WMI INDUSTRIES, LTD.

The fiberglass that needs to be removed on the GRAVITRON panels is to facilitate visual inspection of the weld on each side of the 3/8" block that the top pins and the floor pins go through. Cutting back the fiberglass 1/2" to 1" from these welds will allow inspection and will not affect the strength of the panel. Enclosed is a drawing indicating the blocks and the area to trim back. The fiberglass does not need to be replaced after inspection.

WMI INDUSTRIES		Merino, CO 80741	
SCALE:	NONE	DESIGNED BY:	DEC 16 1991		
DATE:	8-22-81	DESIGNED BY:	K.V.W.		
SAFETY INSPECTION & MODIFICATION					
COMPARISON			GRAVITRON		
			W 170

GRAVITRON PANEL

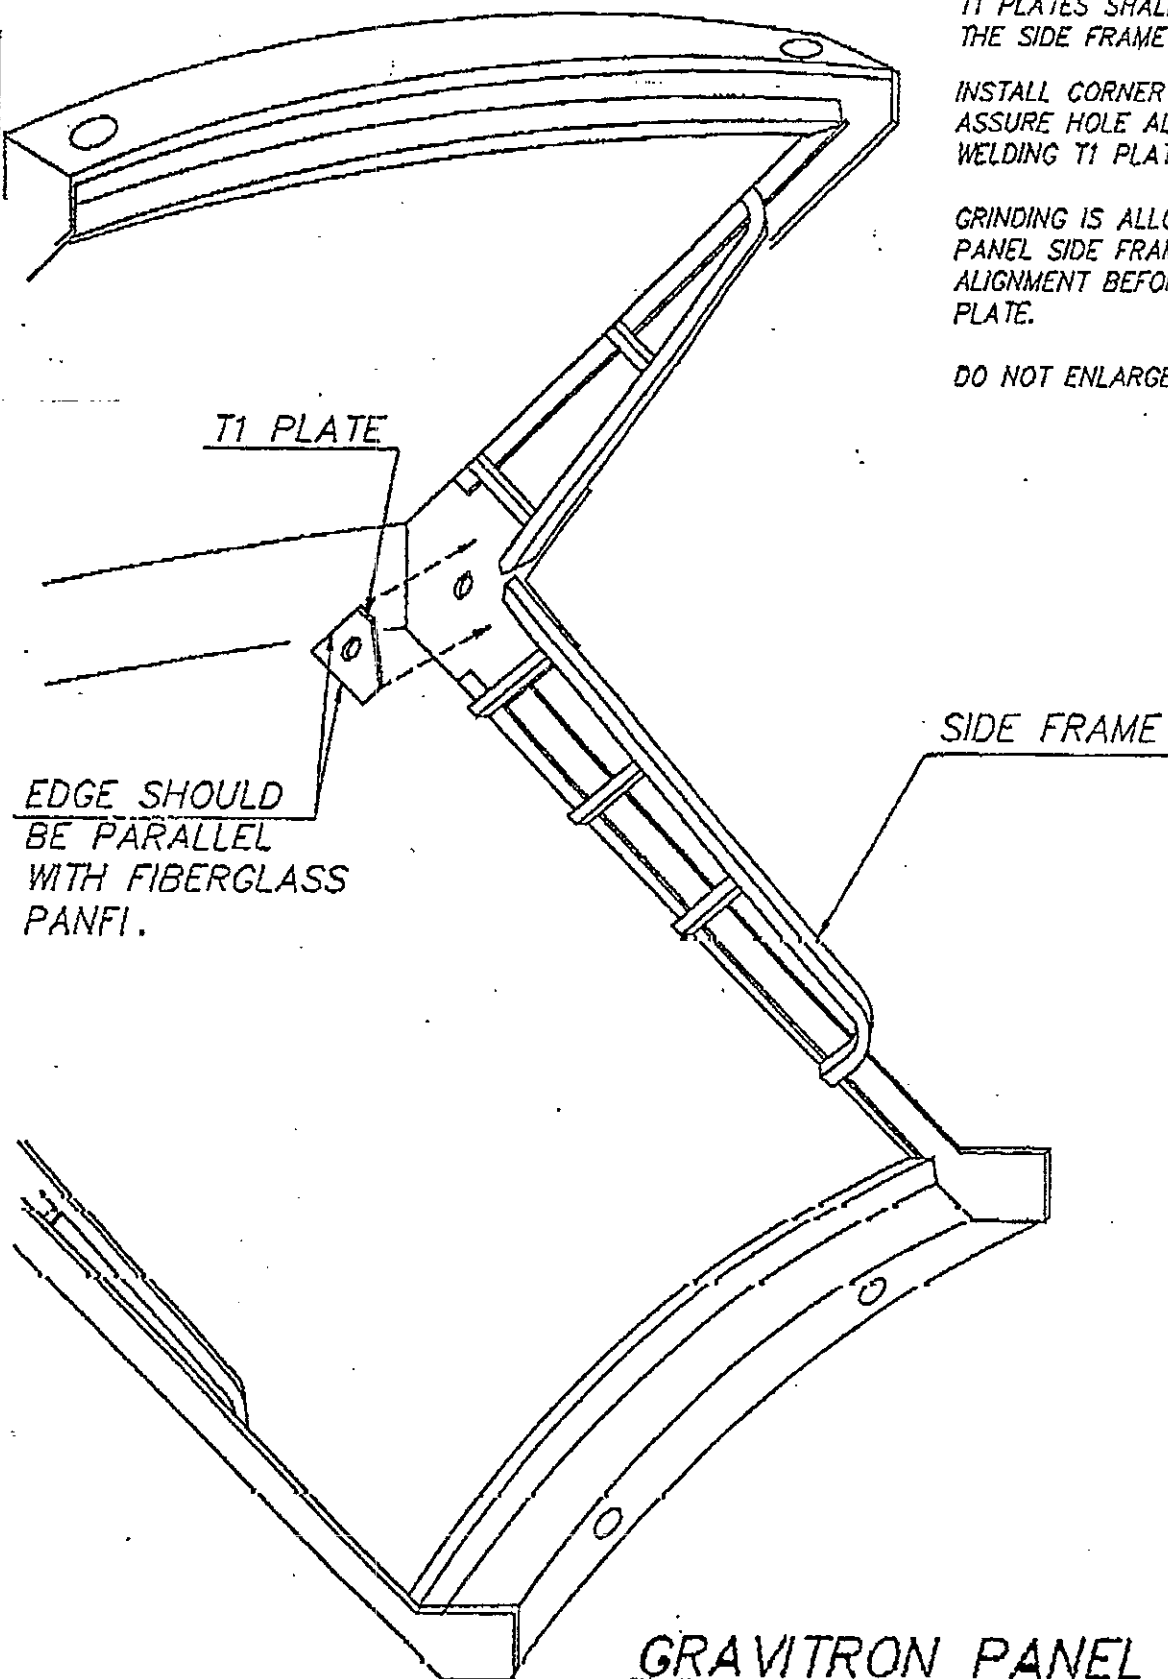
Large Radius
(2") to
prevent
cracking
centered between
tubes.
Maximum Size

INSTALL CORNER PIN IN PANELS TO ASSURE HOLE ALIGNMENT BEFORE WELDING T1 PLATE IN PLACE!

GRINDING IS ALLOWED ON HOLE IN PANEL SIDE FRAME TO IMPROVE PIN ALIGNMENT BEFORE INSTALLING T1 PLATE.

DO NOT ENLARGE HOLE IN T1 PLATE.

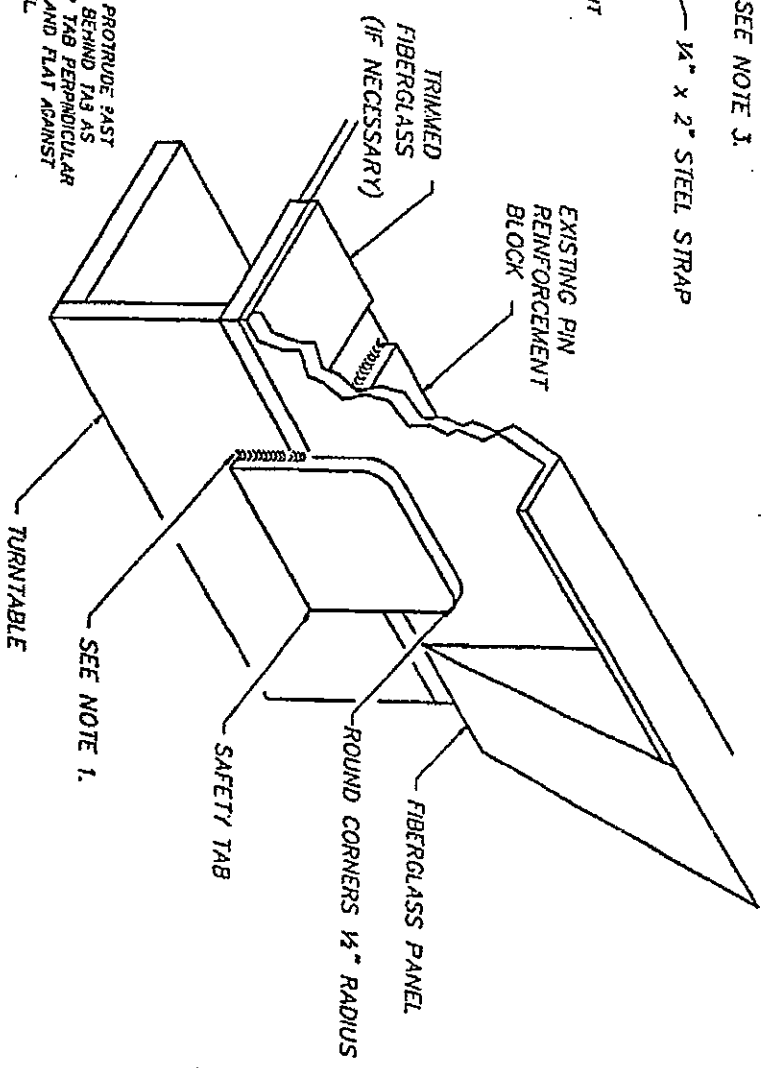
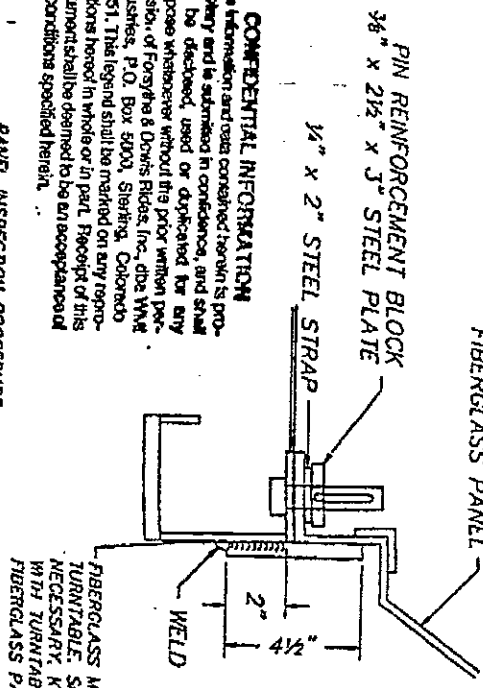
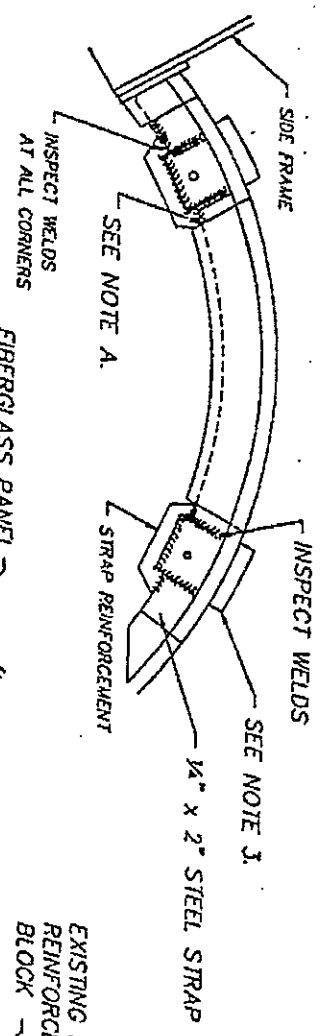
- A. TRIM FIBERGLASS BACK 1" FROM WELD ON PIN REINFORCEMENT BLOCK ON INSIDE OF PANEL IF NECESSARY FOR BETTER WELD INSPECTION.
- B. INSPECT STRAP, PIN REINFORCEMENT BLOCK & WELDS FOR EXCESSIVE WEAR, DAMAGE OR FRACTURES.

- 1. WELD SAFETY TAB TO OUTSIDE OF TURNABLE OPPOSITE PIN AROUND OUTSIDE PERIMETER OF TAB.
- 2. 30 SAFETY TABS REQUIRED FOR RETROFIT.
- 3. SAFETY TABS ARE TO BE PLACED 2 PER PANEL EXCLUDING DOOR.
- 4. TABS ARE 3/8" x 4" x 4 1/2" STEEL PLATE.
